Access Compliance Report

Public Rights-of-Way

(Curb Ramps)

Intersection ID: 50595	Main Street: BENDING_BRANCH_RD	Cross Street: GRAY_WILLOW_RD	Location: N
ADA ID: 5FB2C718875B	Ramp Type: Perp	Initial Pass/Fail: Fail	Overall Compliance: No
Severity Score: 33.75			
Codes/Mitigation Info/Possible Solution		Field Measurements/Component Compliance

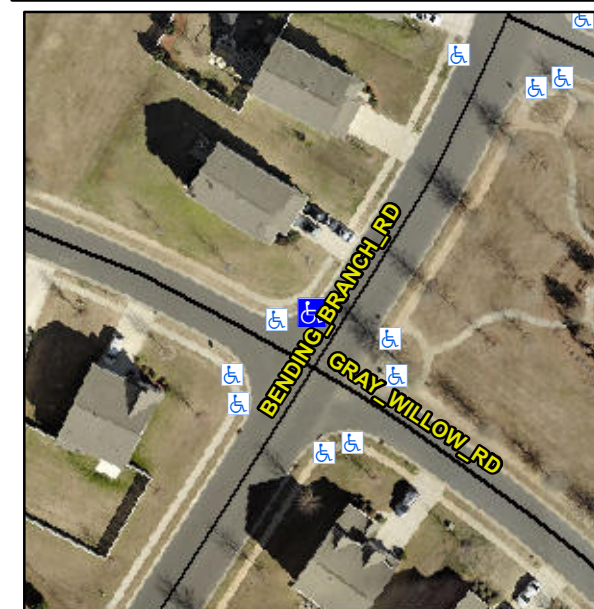
Not Found, R304.5.1, R304.2.2

Compliance	Description	Data	Compliance	Description	Data
N/A	Ramp Length (in)	49.0	No	Ramp Slope (%)	15.4
No	Ramp Width (in)	47.0	Yes	Ramp XSlope (%)	1.4
N/A	Flare Type LT	N/A	N/A	Flare Type RT	N/A
N/A	Flare Slope LT (%)	N/A	N/A	Flare Slope RT (%)	N/A
N/A	Flare Traversable LT?	N/A	N/A	Flare Traversable RT?	N/A
N/A	Landing Length (in)	N/A	N/A	DWS Provided?	N/A
N/A	Landing Width (in)	N/A	N/A	DWS Contrast?	N/A
N/A	Landing Slope (%)	N/A	N/A	DWS Length (in)	N/A
N/A	Landing X Slope (%)	N/A	N/A	DWS Full Width?	N/A
N/A	Landing Curb? (Y/N)	N/A	N/A	DWS Offset (in)	N/A
N/A	Shared Landing?	N/A			
N/A	Gutter Ponding?	N/A	N/A	Gutter Slope (%)	N/A
N/A	Gutter Lip Ht (in)	N/A	N/A	Gutter X Slope (%)	N/A
N/A	Painted X Walk1?	No	N/A	Painted X Walk2?	N/A
	X Walk 1 Direction	To SE		X Walk 2 Direction	N/A
N/A	X Walk 1 Width (in)	N/A	N/A	X Walk 2 Width (in)	N/A
	X Walk 1 Slope (%)	0.2		X Walk 2 Slope (%)	N/A
	X Walk 1 X Slope (%)	1.2		X Walk 2 X Slope (%)	N/A

Remove & Replace Entire Ramp.
